Re: A & J Cartage Site Plan Review letter dated January 19, 2022

Re: A & J Cartage Site Plan Review letter by SAFEbuilt dated January 20, 2022

Re: A & J Cartage Site Plan Review No. 1 dated January 19, 2022

SITE PLAN FOR A & J CARTAGE

TITLE: UTILITY PLAN

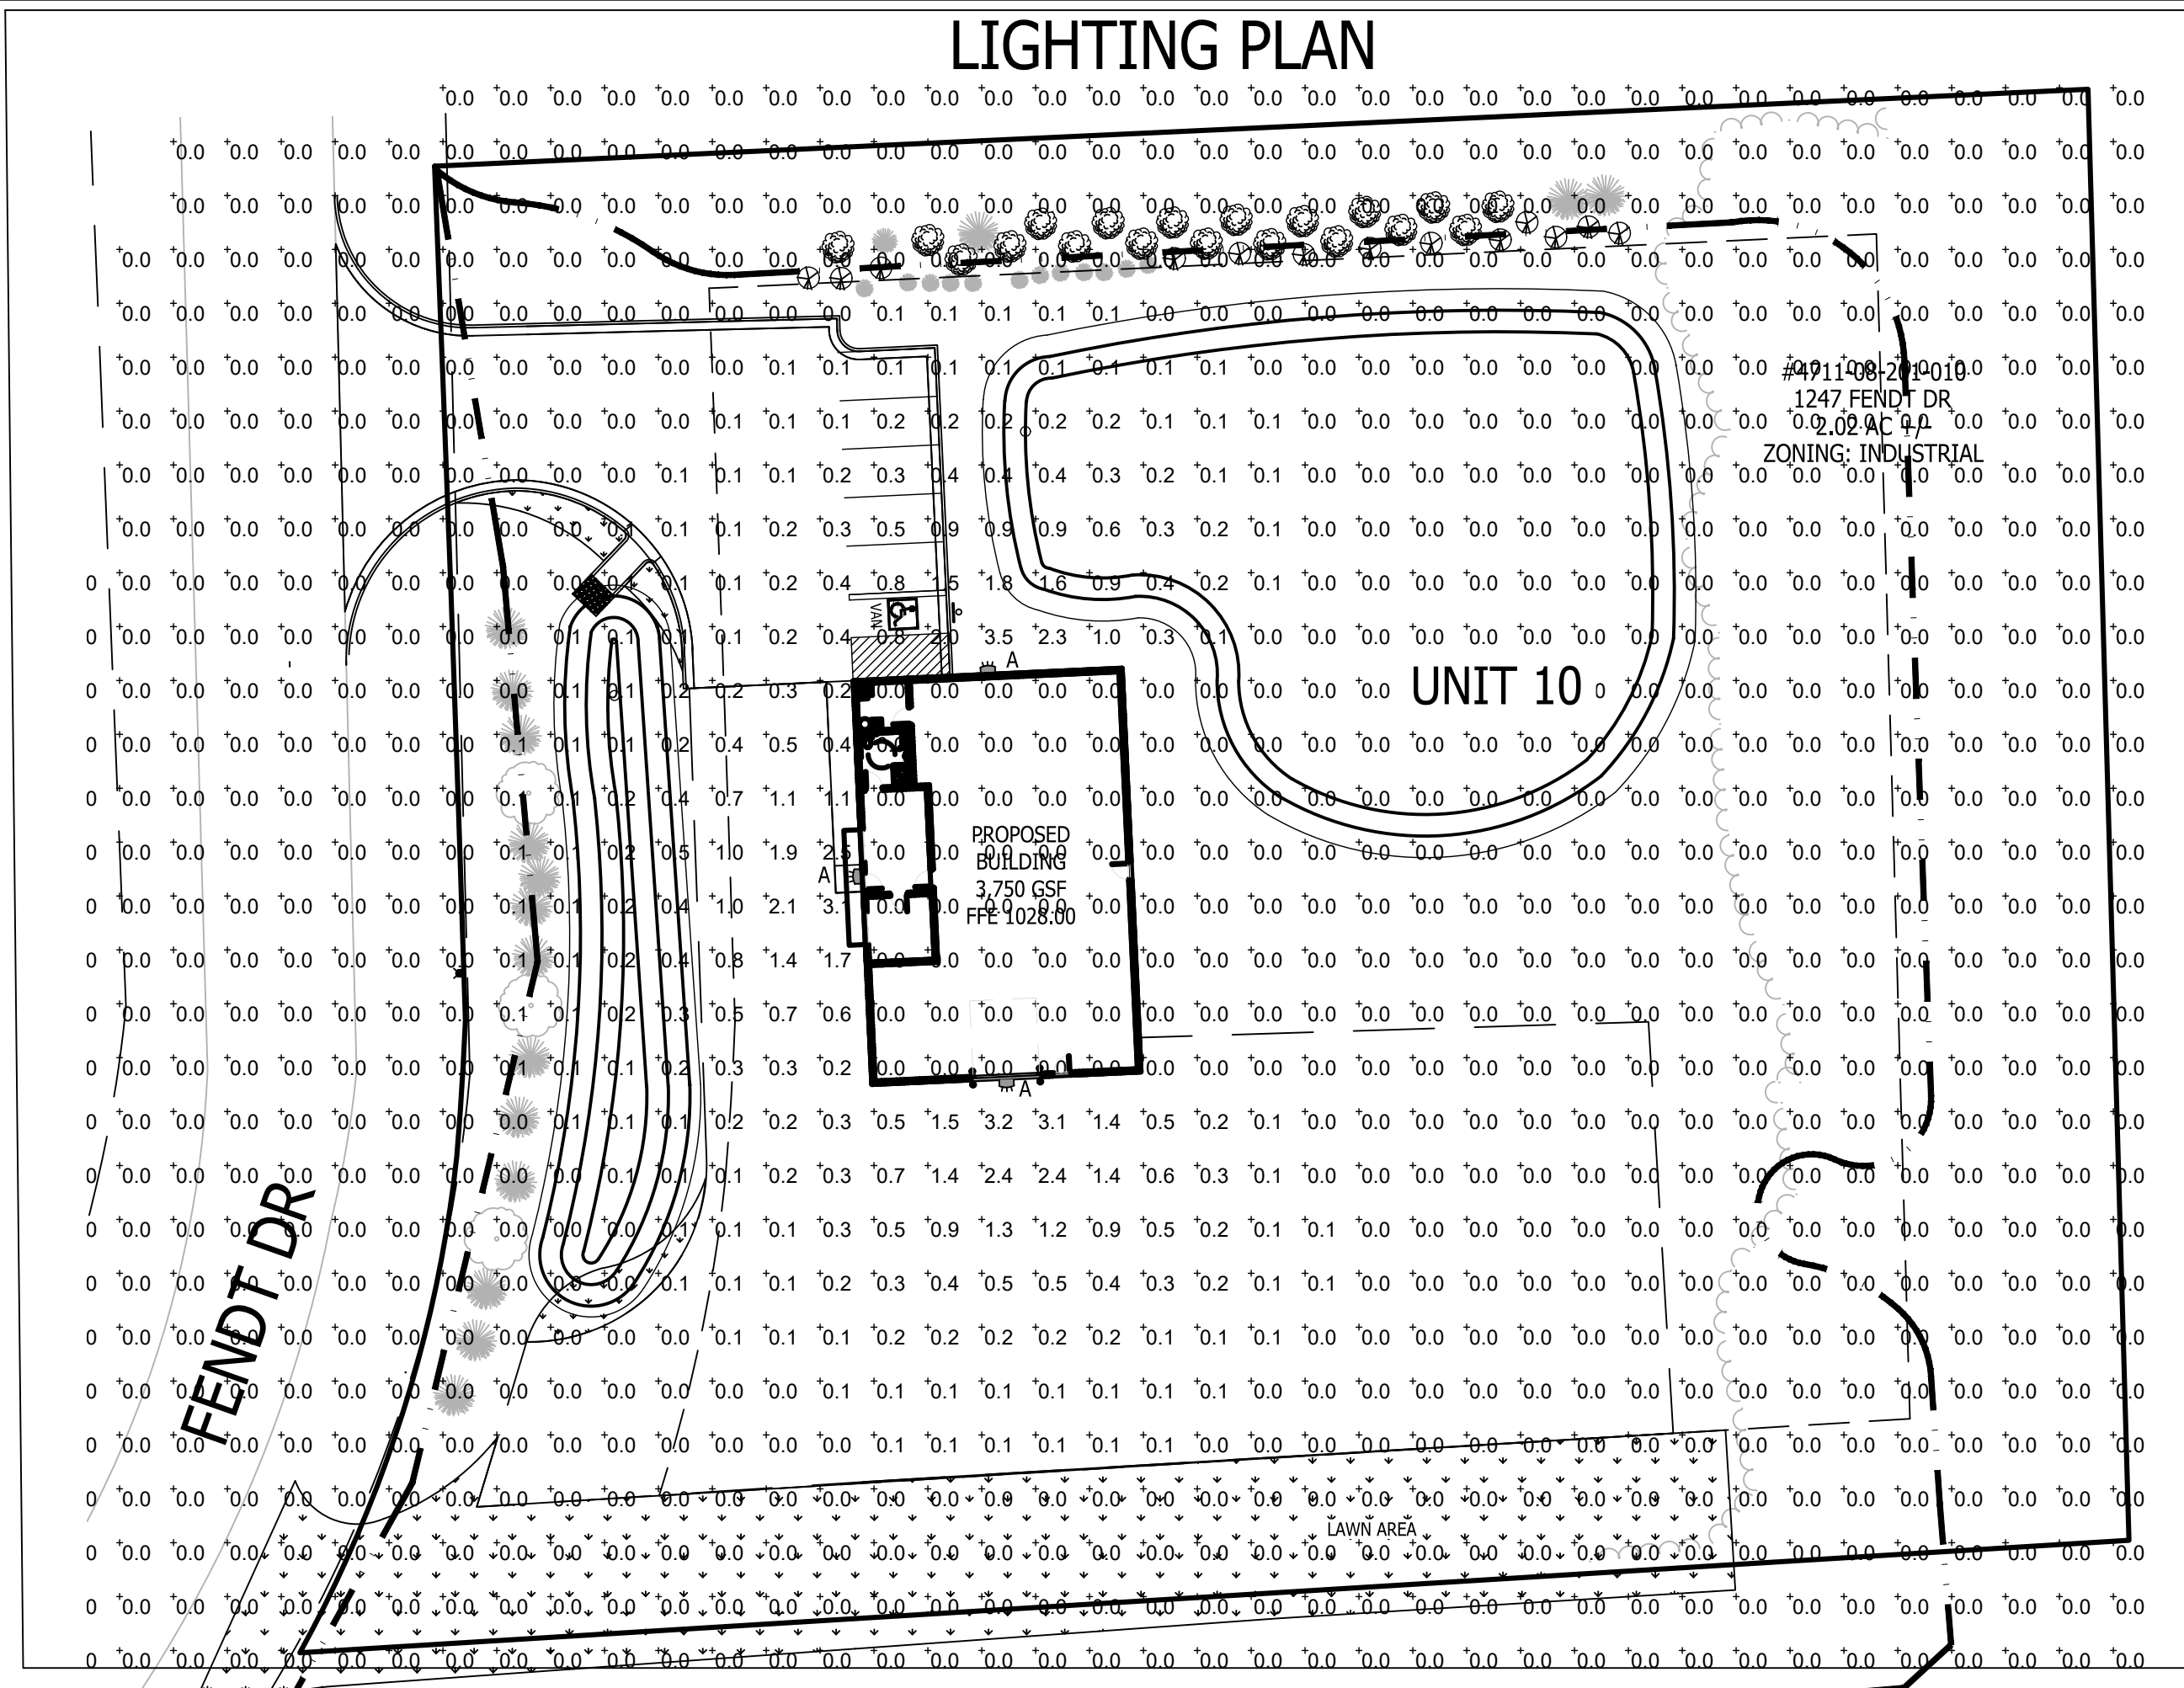
1. On-site detention basin with forebay has been added. See calculations on Utility Sheet 5.
2. ACKNOWLEDGED. According to Genoa Township Zoning Ordinance Article 8.02.02(b)(3) Industrial Districts Outdoor Sales or Storage, "...The Township Board, following a recommendation of the Planning Commission and the Township Engineer, may approve a gravel surface for all or part of the display or storage area for low intensity activities, upon finding that neighboring properties and the environment will not be negatively impacted." No new impacts are expected for the site. Existing use will continue with the same traffic volume: 2 tractor-trailers leaving the site Monday through Friday from 6-8 a.m. and returning to the site between 6-7 p.m.

2. This has been revised, see Utility Plan Sheet 5.
3. The water service has been changed to 1-inch, see Utility Plan Sheet 5.
4. Notes have been added to the Site Plan Sheet 3 that gravel areas adjacent to the new drive should be restored with topsoil, seed and mulch. In addition, gravel currently within the south side yard setback will be removed and re-stored with topsoil, seed and mulch.
